REVISED NOTICE OF DECISION

1951 Schurman Warehouse and Office

Land Use Application Nos.:	SPR 22-004 (Site Plan Review – Type 2) SEP 22-004 (SEPA)
Applicant:	Wilson Architects PLLC C/O Rusty Muyuela 404 E. 15 th St #7 Vancouver, Washington, 98663
Property Owner:	DT Realty LLC Mark Dawkins 610 NW 16 th Cir Ridgefield, WA, 98642
Site Location:	1951 Schurman Way Woodland, WA 98674
Parcel & Size:	507870102, 3.06 Acres
Zoning Designation:	Light Industrial, I-1
Date Application Received:	October 28 th , 2021
Notice of Application & Likely DNS issued:	Revised: May 11 th , 2022 Original: April 28 th , 2022 [See: case # SEP-22-004]
Comment Period & SEPA Appeal Period Ended:	Revised: May 25 th , 2022 Original: May 12 th , 2022
Notice of Decision Issued:	Revised: June 1 st , 2022 Original: May 31 st , 2022
DRC Decision:	Approve with Conditions

STABILIZED CONSTRUCTION ENTRANCE						E-05
APPROVED	REVISIONS	DATE	DRAWN	DESIGNED		
PUBLIC WORKS DIRECTOR		DATE

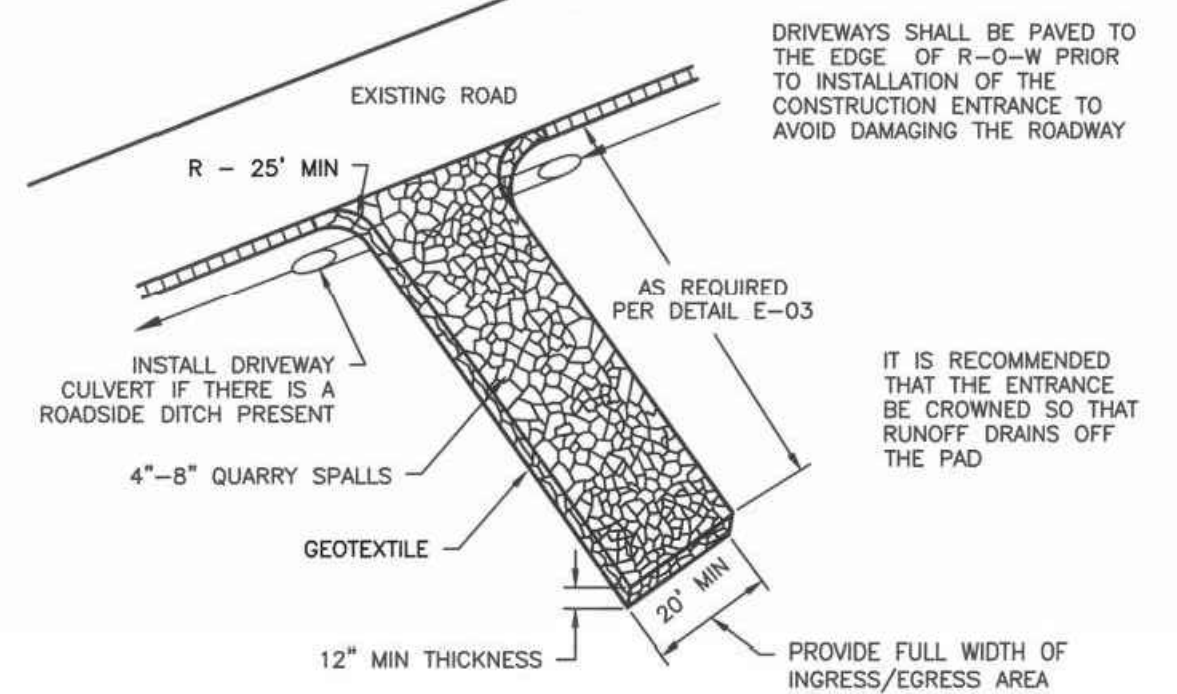
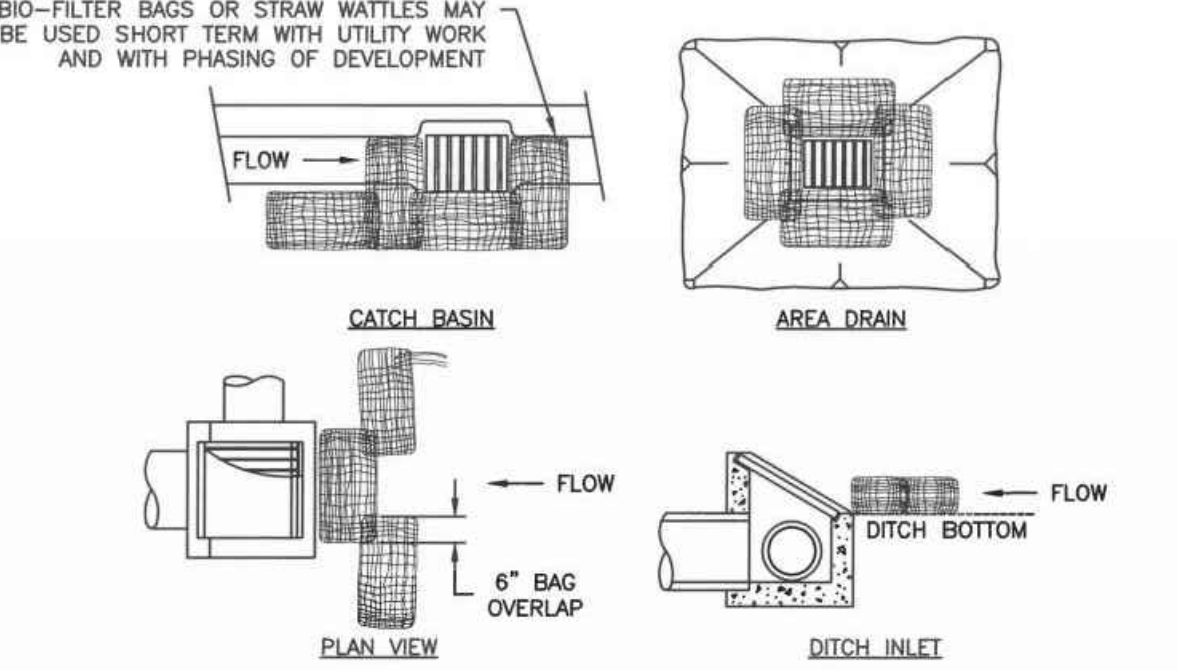
Finding 13B: Construction Entrance meets the width requirements as defined within City of Woodland Std. Details E-03 and E-05 but not the length requirement. The site will have more than one-acre exposed soil and the Construction Entrance shall be 100-foot minimum length. Please revise this sheet to show a minimum 20-foot wide by 100-foot-long Construction Entrance. *(See condition 11)*

11. Revise the proposed construction entrance as directed to ensure accordance with WMC.

**South Biofiltration Swale
Typical Section**
NTS

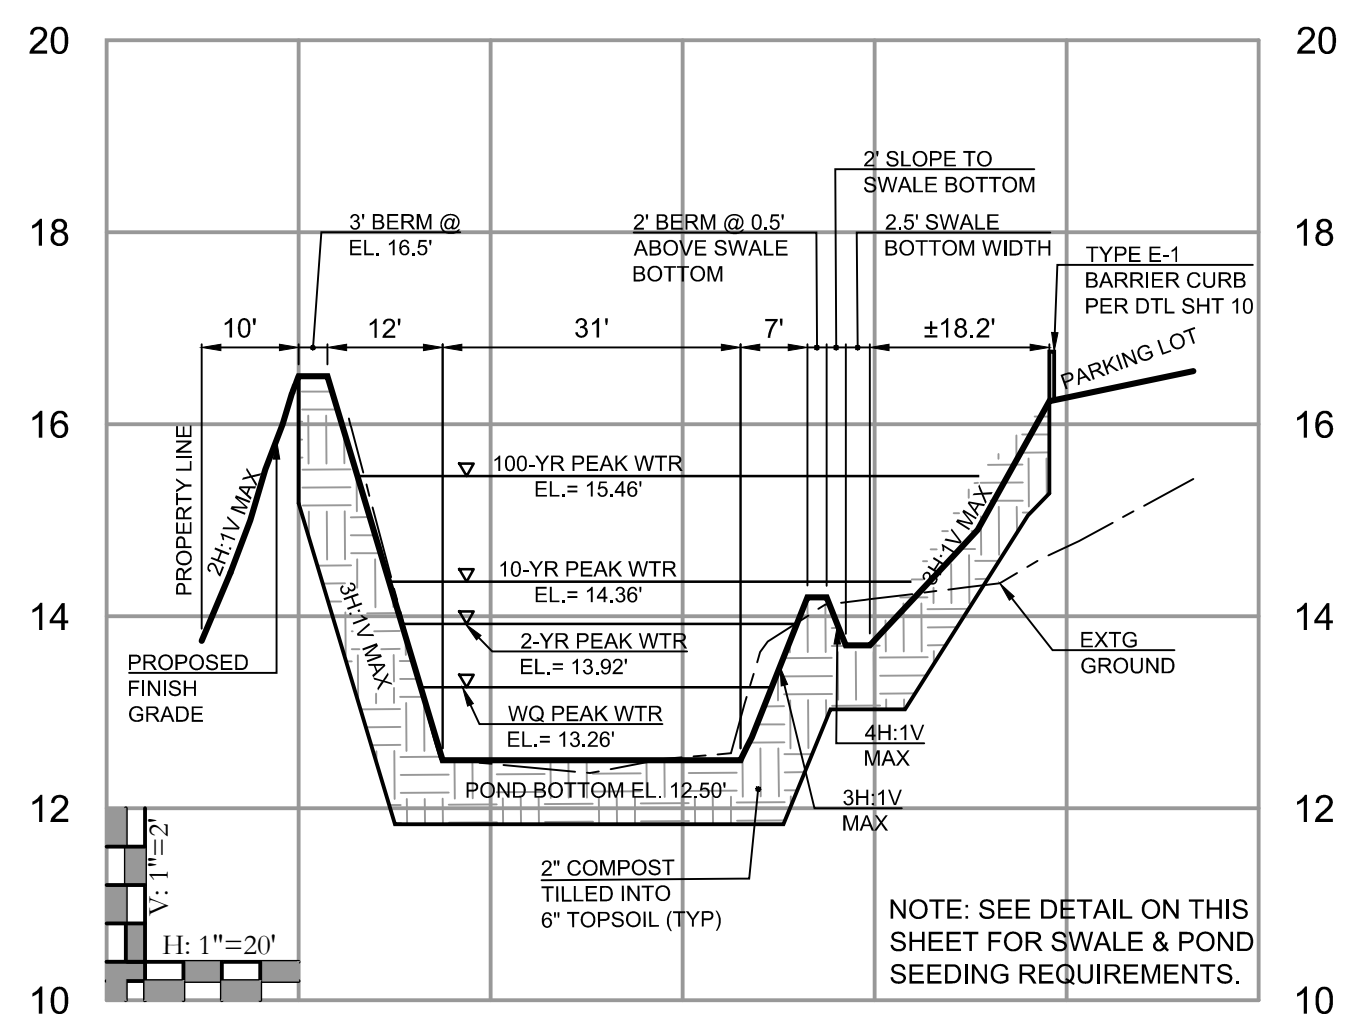
1. Woodland MC 15.12.080, Quantity Control, requires 2-, 10-, 25- and 100-year, 24-hour storm events. 25-year not included.
 - a. Add 25-year, 24-hour storm values to Table 1 and Table 2.
2. Bioswale 11R, model lists 2.5' width at bottom, plans show 2'.
 - a. Revise the HydroCAD model for 2-foot-wide swale bottom or revise plans to show 2.5-foot-wide swale bottom.
3. Per Appendix III-6.1 of the 1992 Puget Sound Manual, biofiltration swales with less than 2-percent slope should include underdrains.
 - a. Provide under drains for the biofiltration swales.

- a. Add 25-year, 24-hour storm values to Table 1 and Table 2.
- b. Revise the HydroCAD model for 2-foot-wide swale bottom or revise plans to show 2.5-foot-wide swale bottom.
- c. Provide under drains for the biofiltration swales.
